A 522483-REPAIR

ON-SITE SEWAGE DISPOSAL SYSTEM
HOWARD COUNTY HEALTH DEPARTMENT
BUREAU OF ENVIRONMENTAL HEALTH

ADDRESS: 4880 Manor Lane PROPERTY OWNER: Joe Thompson

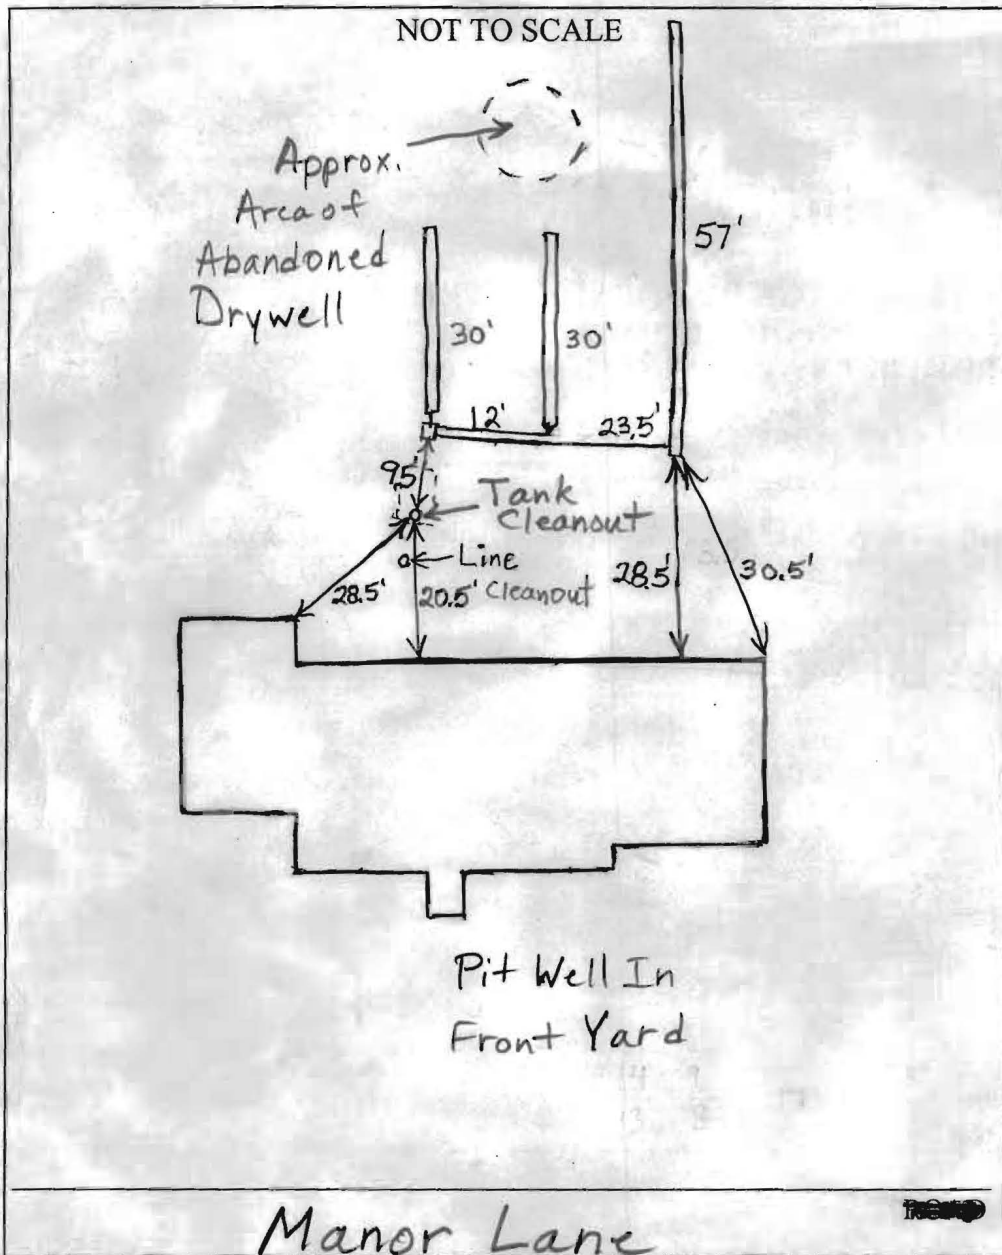
INSTALLATION 6/10/05 Old drywell pumped out and filled with dirt per Robert Fryock. Robert dug 57' trench too deep. Only 3.5' of buffer above water. Still new system is shallower than old drywell. O.K. to backfill. (BB)

5/26/05 - Homeowner originally said its
a 3 bedroom house. (E)

5/27/05 - T/c from Skip, now homeowner is
saying its 4 bedrooms (E)
